**CASE:**  
Z14-059

**PROJECT:**  
BELLAGIO BROWN RD - MONTICELLO

**REQUEST:**  
REZONE FROM RS-43 TO RSL2.5 PAD AND SITE PLAN REVIEW. THIS REQUEST WILL ALLOW FOR THE DEVELOPMENT OF A SINGLE-RESIDENTIAL SUBDIVISION.

## Planning and Zoning Board

**SITE PLAN**  
 MONTICELLO

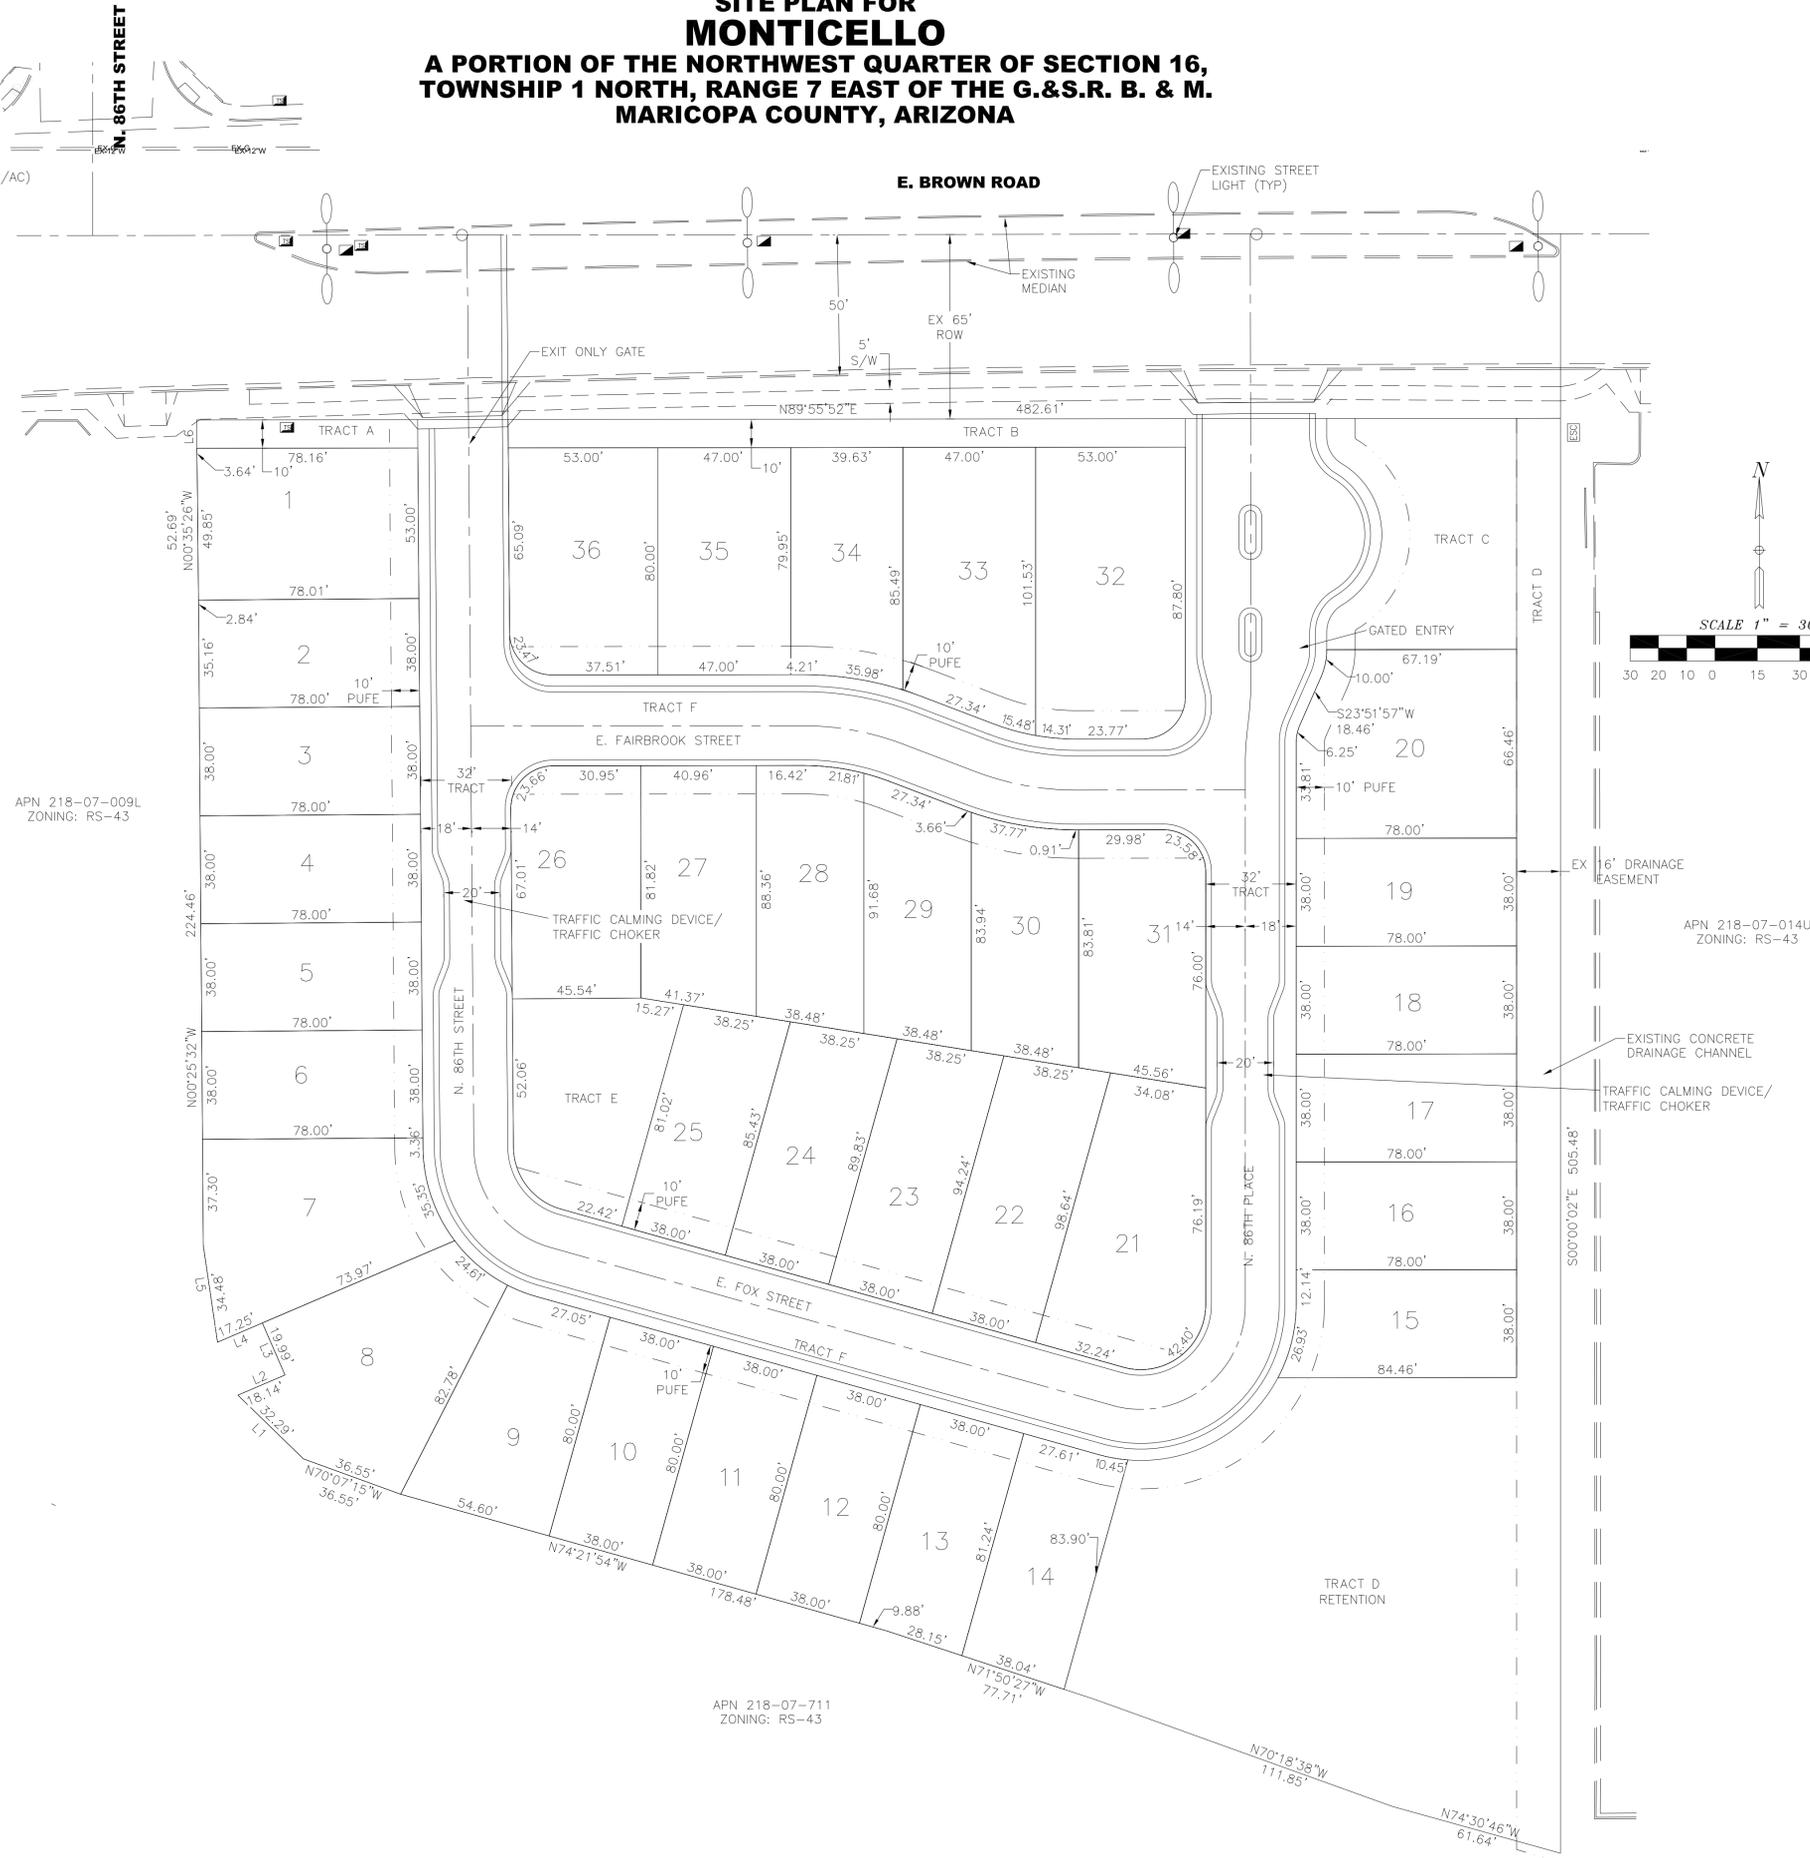
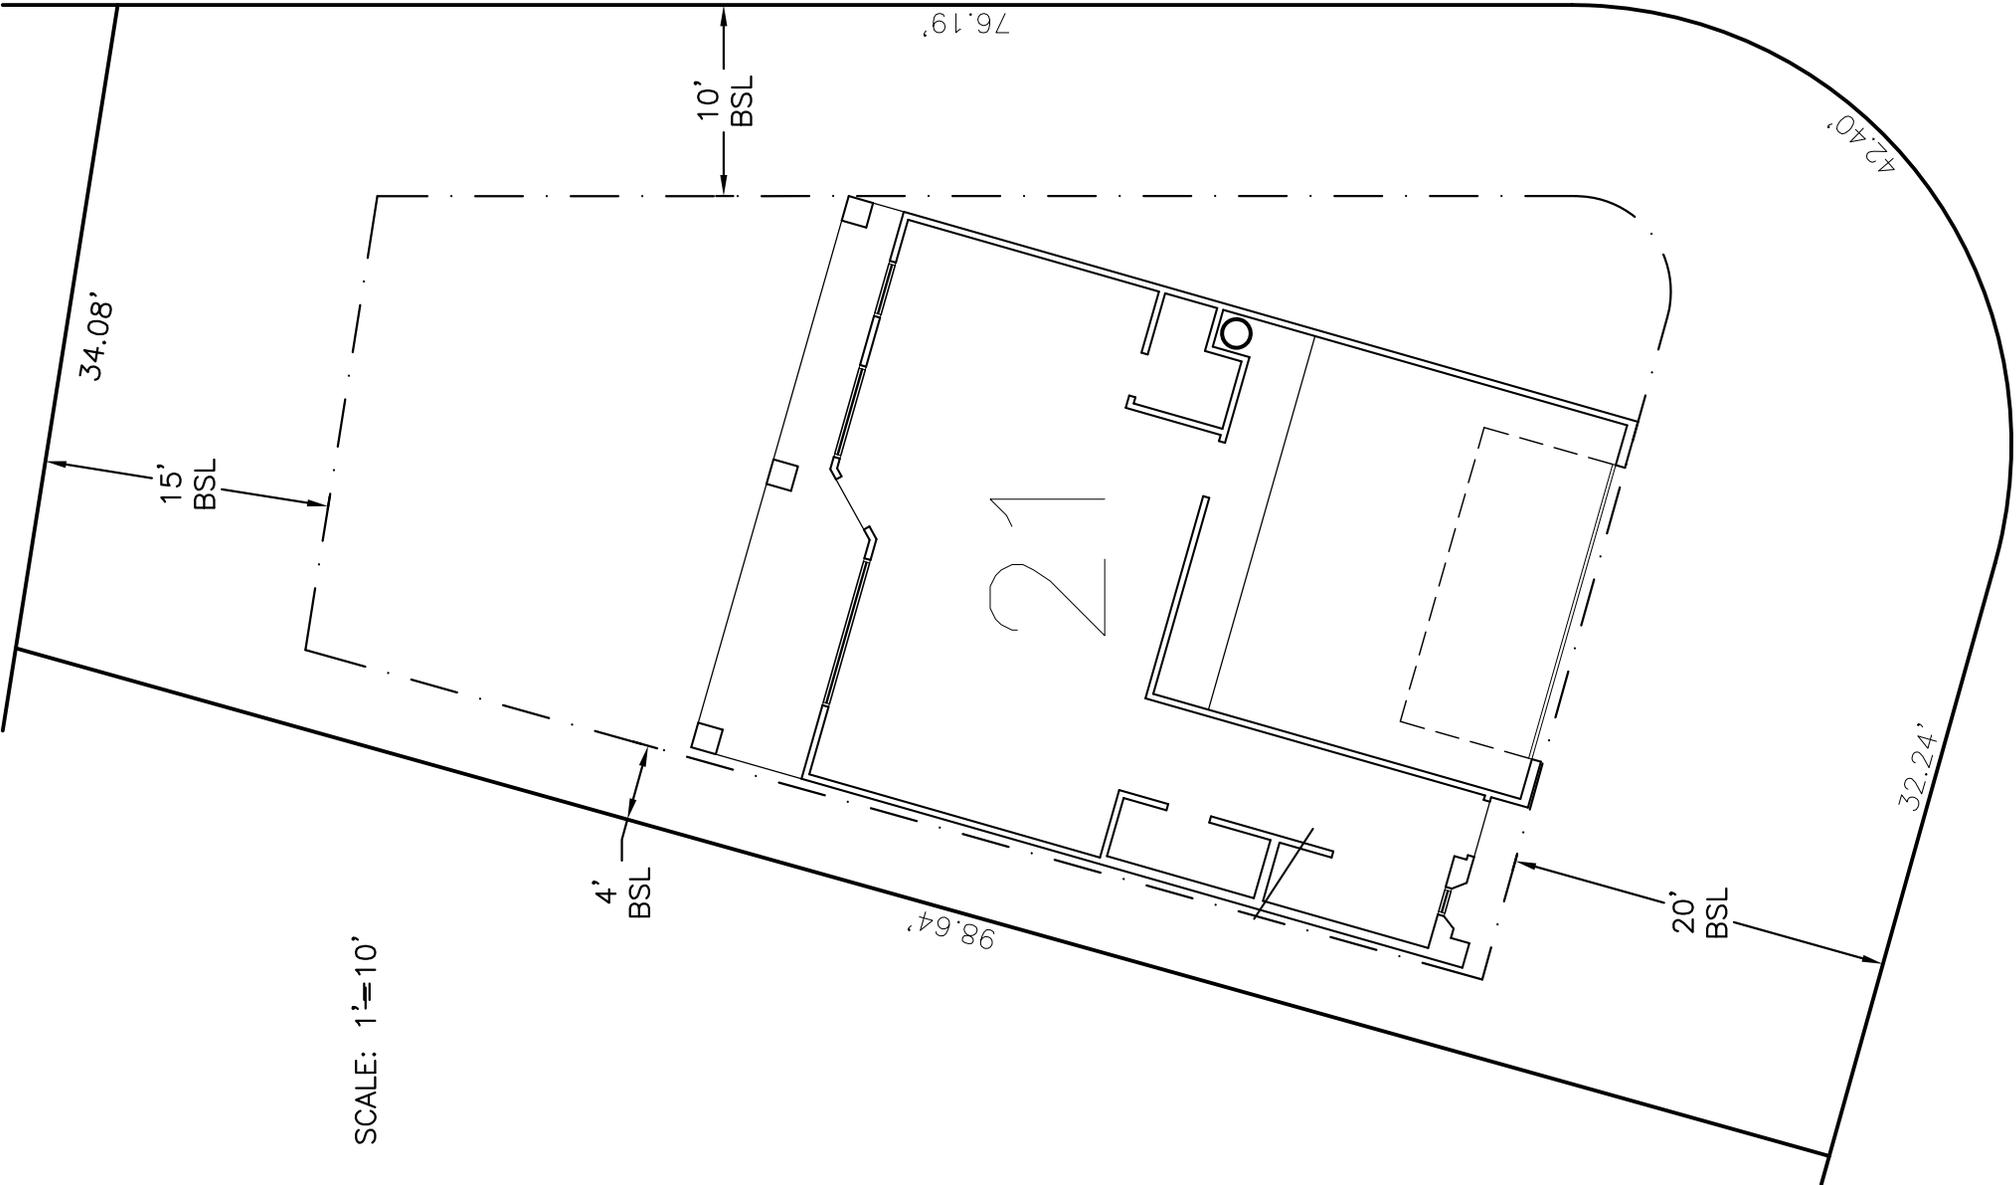
In reviewing the overall plan as previously noted the lots and layout are typical or conventional. The site plan indicates 18.8% of open space, with a pool proposed on a separate 3,712 square foot tract and a retention area at the southeast corner of the development, which is 27,137 square feet in area. The larger open space area is pinched off from the street with the sides of homes, which limits visibility into this area. Staff has commented about fronting lots on the open space to provide natural surveillance and begin to create spaces that the community would naturally gather. Staff also raised concerns that a 36 lot subdivision would not be able to support a pool as an amenity long term. The applicant is confident that the number of lots is sufficient to support a small pool area and that the location of the open space is appropriate with lots siding onto it. One alternative would be to relocate Tract E, which contains the pool to the location on the site plan identified as lot 21. Grouping the two open space areas would create a central area for neighbors to gather and interact, allowing families to enjoy all of the amenities without being in separate locations.

In review of the housing product design for the project it is apparent that the product design is not in conformance with the Building Form standards established in the Zoning Ordinance, which are intended to minimize the garagescape appearance of our residential streets and to bring the livable area with porches closer to the street to activate the front of the house and the neighborhood. In review of the floor plans submitted, it seems as though some fairly minor adjustments could be made to the product to comply with these standards. In order to ensure the necessary proportions and variations, Staff has added a condition of approval requiring Administrative Product Approval by the Planning Director. During that review, staff will continue working with the applicant to ensure high quality elevations.

4. **Lots 1, 32, 33, 34, 35 and 36 indicated on the site plan are limited to single-story homes. No two-story products shall be built on these lots.**
5. **No two identical elevations are permitted on adjacent lots or on lots across from each other.**

7. **Relocation of the pool open space area to lot 21 so that it is located more closely to the larger open space retention area with an enhanced pavement surface between the two open space areas.**
